Access Compliance Report Public Rights-of-Way (Curb Ramps)

Main Street: LA_COLINA_DR Cross Street: N/A Location: S

ADA ID: RPRK220125114641 Ramp Type: Type 1 - Perpendicular Diagonal Initial Pass/Fail: Fail Overall Compliance: No Severity Score: 30

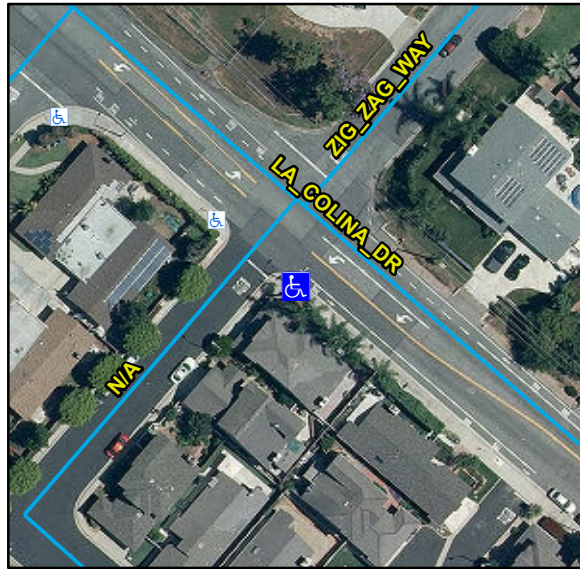
R304.2.2, R304.5.3, R302.7.2, STD 1115

Remove & Replace Curb Ramp With Two New Directional Ramps or Equivalent. Grind Gutter Lip.
